DATE: January 10, 2020
TO: Blue Bird Owners
Subject: RECALL R19AF, Safe Fleet Prolo Roof Hatch Handle

IMPORTANT SAFETY RECALL NOTICE

Subject: Safety Recall 19E-042 – Prolo Hatches

OUTER HANDLE REPLACEMENT

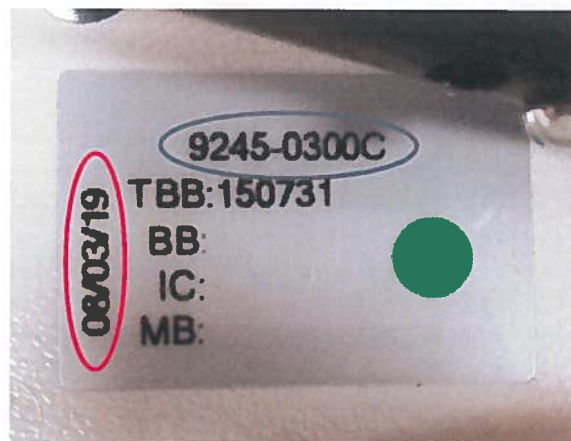
SMI has determined that some Prolo Hatches may contain defects (voids/porosity) in the outside release handle that have resulted from the casting process. Excess voids and porosity may create failure points in the handle that can lead to breakage under reasonable use. Failure of the external release handle will prevent the hatch release mechanism from being actuated from outside the vehicle. The hatch can still be opened from the outside by venting the hatch and actuating the inside release handle however this operation is not intuitive and not detailed in the required instructions located on the hatch. Failure of the external release handle does not prevent actuation of the release mechanism from inside the vehicle.

1. Check the label on the bottom of the Prolo Hatch p/n 92XX-XXXXX (circled below in blue) for dates between August 1, 2018 and May 20, 2019 (circled below in red). Units built within this date range are subject to the replacement campaign.

Replacing the outside release handle will resolve the defect. The replacement kit will include (1) replacement handle, associated hardware, and replacement instruction information.

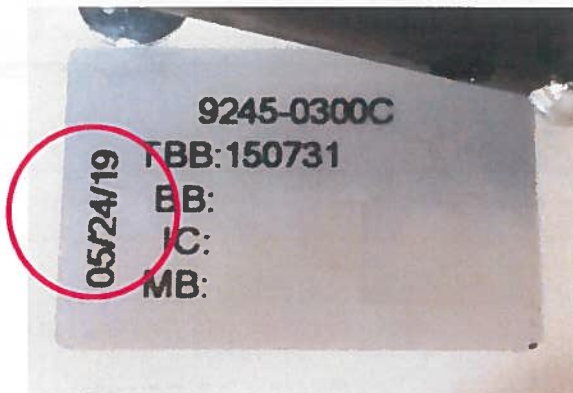
Step 2: Locate the silver "build date" sticker on the inside of the lid (located in red circle shown above)
